From: LabriePlus Service

Model: Expert and Automizer

Subject: New parts- Labrie Dash Light

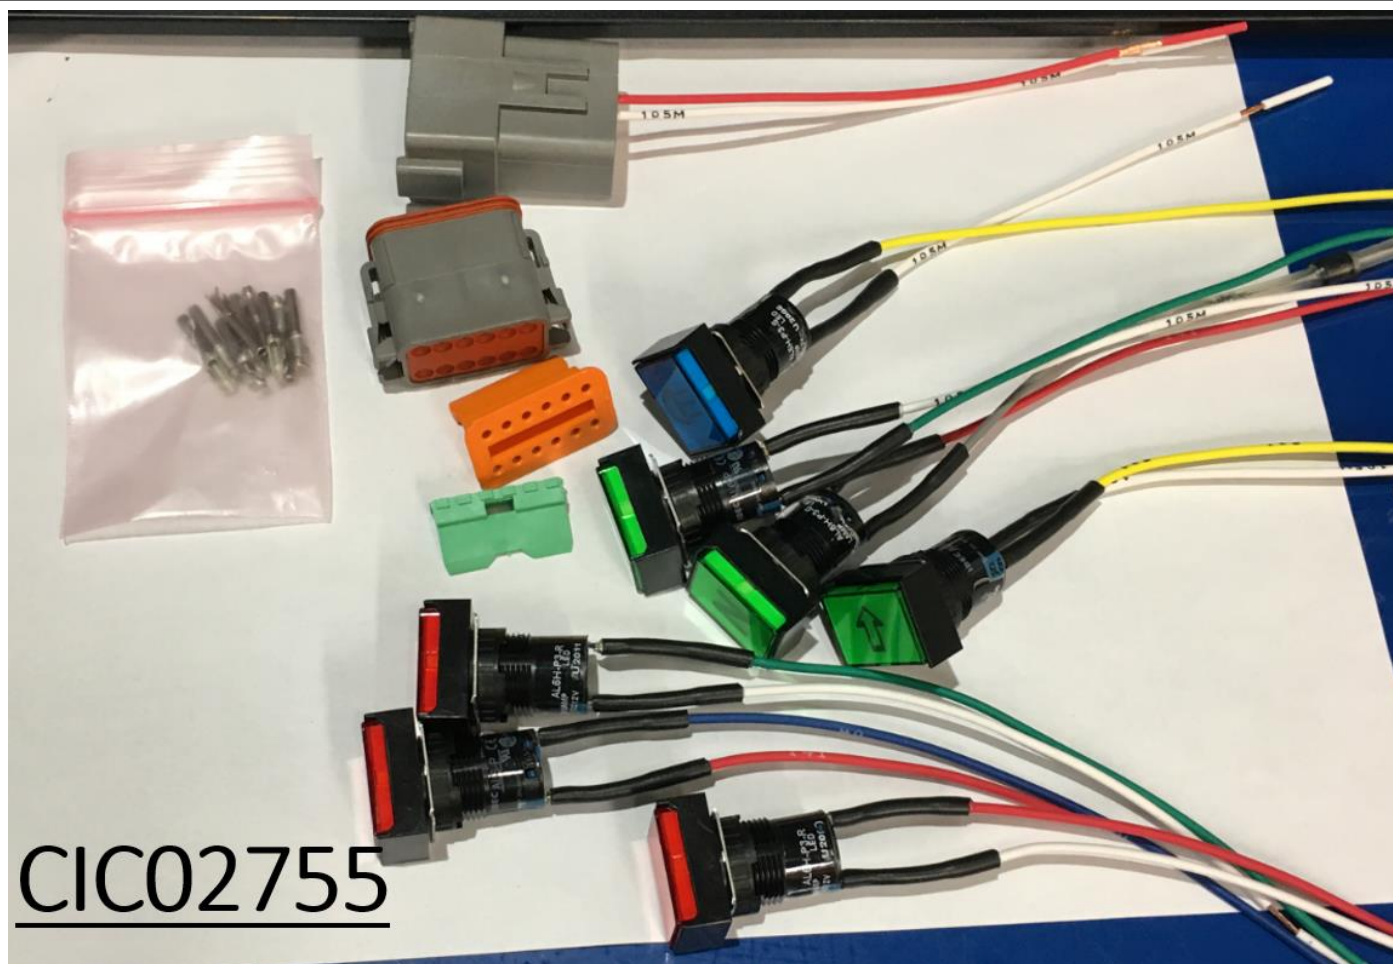
Earlier Lights- ELL00402

New Dash Lights- CIC02755

The earlier Labrie dash light assembly, **ELL00402**, is now discontinued by the supplier. If you need to replace part of the old one, you will need to change the entire **ELL00402** assembly to **CIC02755**, along with plate **210377** and use electrical diagram **151092** for a description of how to modify the connection.

Procedure to change ELL00402 (old lights) for CIC02755 (new lights)

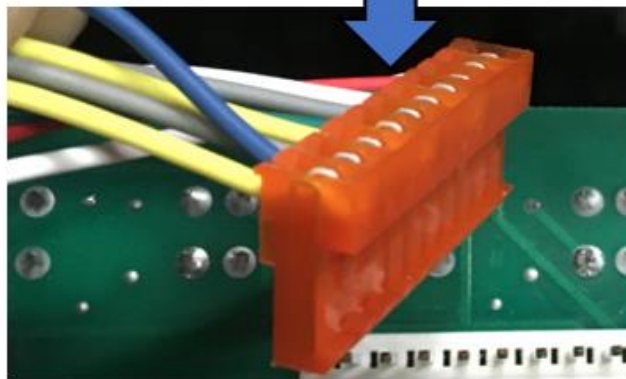
REMOVED ORIGINAL CONNECTOR TYCO

INSTALLED DEUTSCH CONNECTOR 12 PINS

(1X) CONNECTOR ELC04500
 (10X) TERMINALS ELT12500
 (1X) LOCK ELC06500

56A	CM1	1	←	1	←	56A
40	2	←	2	←	40	
538	3	←	3	←	538	
52	4	←	4	←	52	
805	5	←	5	←	805	
805	6	←	6	←	805	
105A	7	←	7	←	105A	
57A	8	←	8	←	57A	
141	9	←	9	←	141	
105M	10	←	10	←	105M	
	11	←	11	←		
	12	←	12	←

DEUTSCH CONNECTOR 12 PINS

(1X) CONNECTOR ELC05500
 (9X) TERMINALS ELT12000
 (1X) LOCK ELC07500
